- a. 2233-2335 North Bank Drive (DEV-01-25) - Review of a Major Site Plan application for National Church Residences (NCR), to allow for a campus redevelopment to include a new headquarters office building and two senior housing buildings. A recommendation to City Council of a plat amendment is also requested.

Subject: 2233-2335 North Bank Drive (DEV-01-25) - Review of a Major Site Plan application for National Church Residences (NCR), to allow for a campus redevelopment to include a new headquarters office building and two senior housing buildings. A recommendation to City Council of a plat amendment is also requested.

RE: North Bank Drive Utility Easement

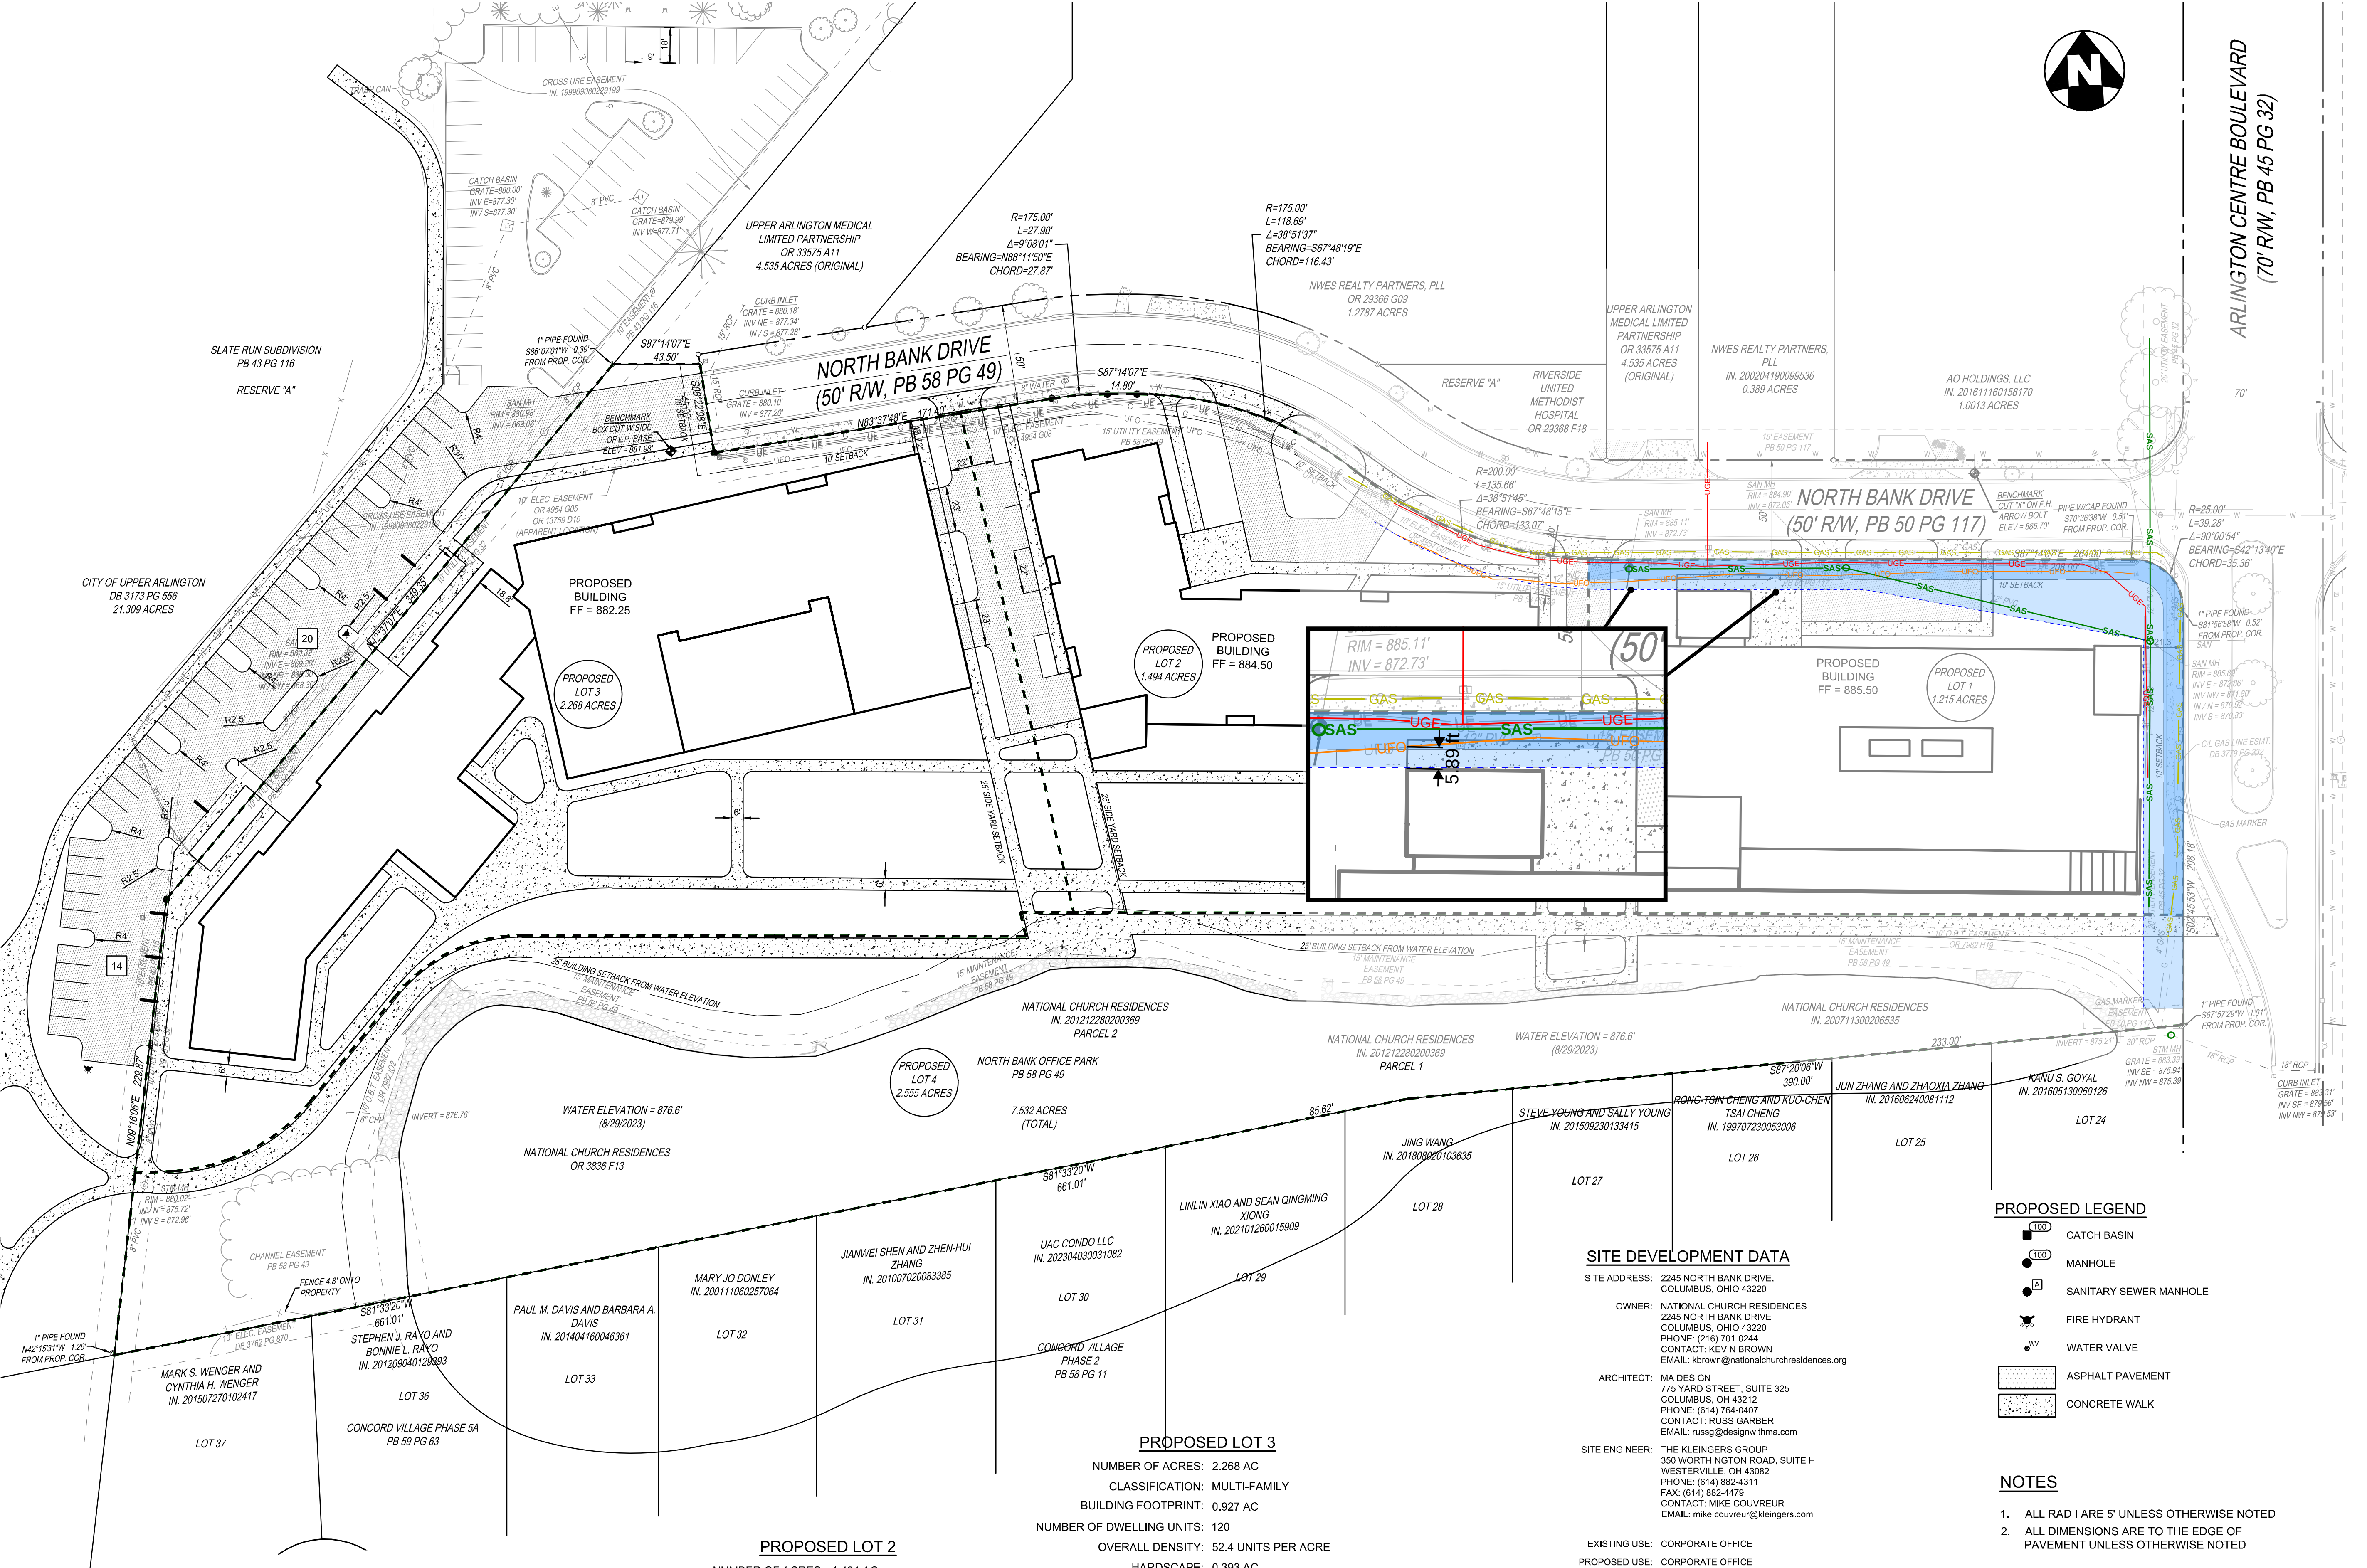
The main conflict point which limits moving the proposed NCR office building further north is the utility easement on the south side of North Bank Drive. The easement is 15 feet wide on its west side and widens to 40 feet near Arlington Centre Boulevard. This easement contains the City's sanitary sewer, which runs parallel to North Bank Drive before making a southeastern diagonal to an existing manhole at the northeast corner of the proposed building. There are also AEP electric lines and fiber optics lines within this easement, also paralleling North Bank Drive, but located further north in the easement. Columbia Gas of Ohio has natural gas lines located nearby as well. [See Page 3.]

If the diagonal sanitary sewer segment were to straighten-out and a new manhole were to be installed, the proposed building could only move five feet to the north.

After meeting with the applicant, Staff agrees that the proposed lobby and conference room portion of the building cannot be relocated so that the building could be pushed even further to the north:

- Differences in grading and finished floor levels between the lobby and parking garage do not allow it to be moved to the west side of the building. This also greatly limits visibility of and access to the building's main entrance. It would also create issues with minimum fire separation distances between this building and the senior housing building per the Fire Code.
- Incorporating it into the office building or parking garage takes away needed office space and parking spaces. The parking garage is already designed at minimum standards (aisle width, space dimensions, etc.). The finished floor level differences would apply here as well.
- Swapping the lobby with the stairs/elevators, and moving the stairs/elevators creates the same issues noted above.

To gain the five feet, the City Engineer has estimated a minimum cost of \$290,000. This includes \$145,000 for the sanitary sewer re-location, where grade/slope issues

The City feels that paying a minimum of \$290,000 to gain an additional five feet of building setback is not a good use of resources. This is especially true when a landscape plan has been submitted, which exceeds code standards for screening along the lake, and will largely mitigate a perceived five-foot difference in the building's location. Staff feels that, due to the reasons above, the requested variance meets the standards of approval, and should be granted.

Exhibit 1: Current vs Proposed Building Footprint

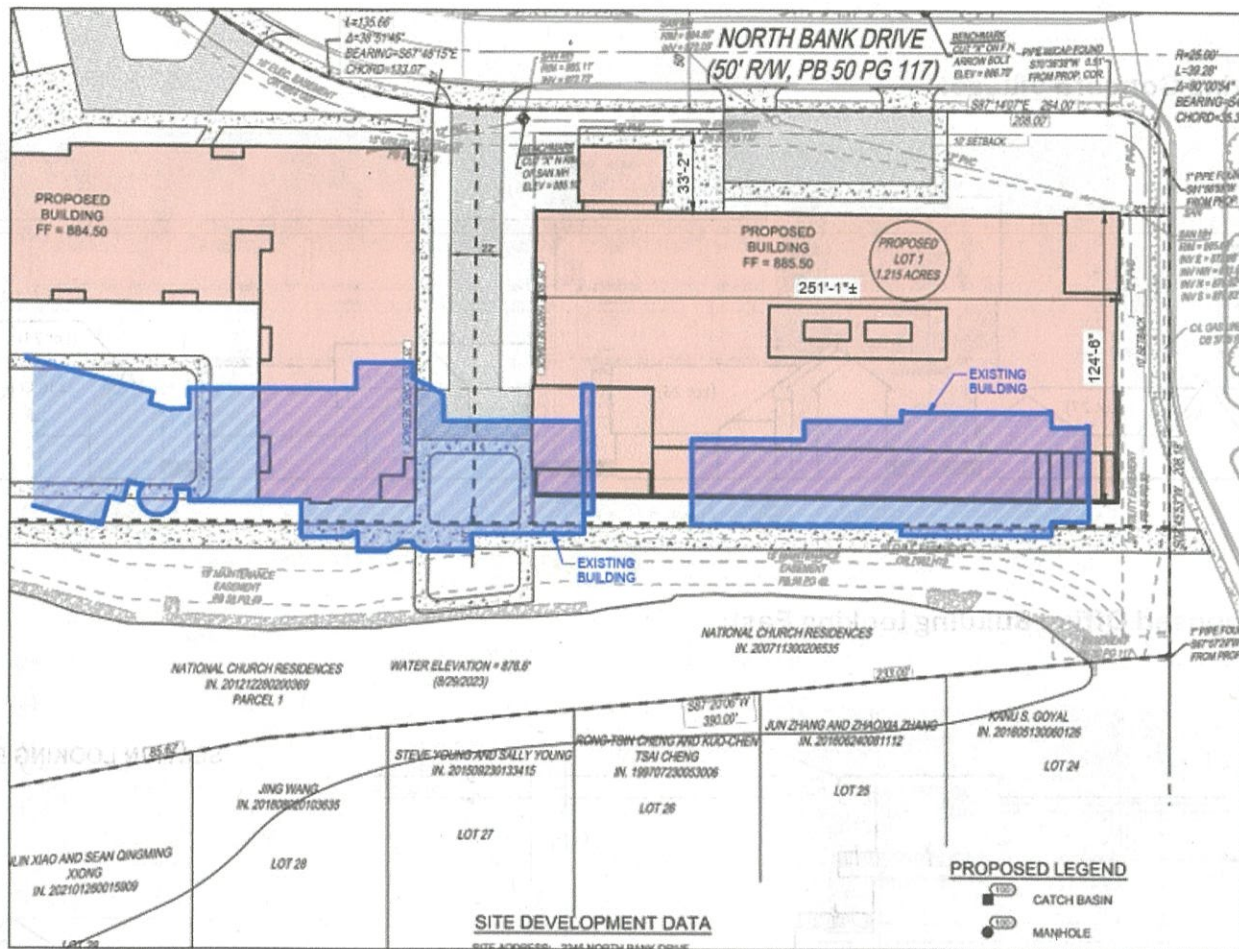
2. Move the proposed NCR Headquarters Office Building closer to North Banks Drive

Issue: The HQ Building will be very close to the residences across the lake. Moving the building to the north, even a small distance, will have a major impact on the HQ building “looming” over the residences.

Diagram:

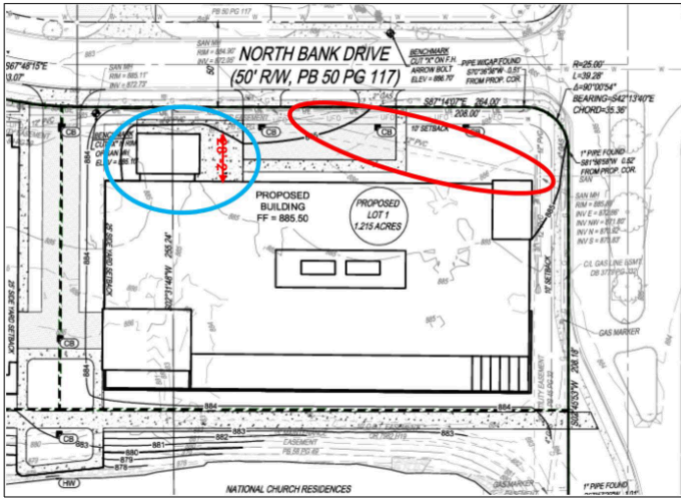
2. Move the proposed NCR Headquarters Office Building closer to North Banks Drive (see commentary related to the map below on next page)
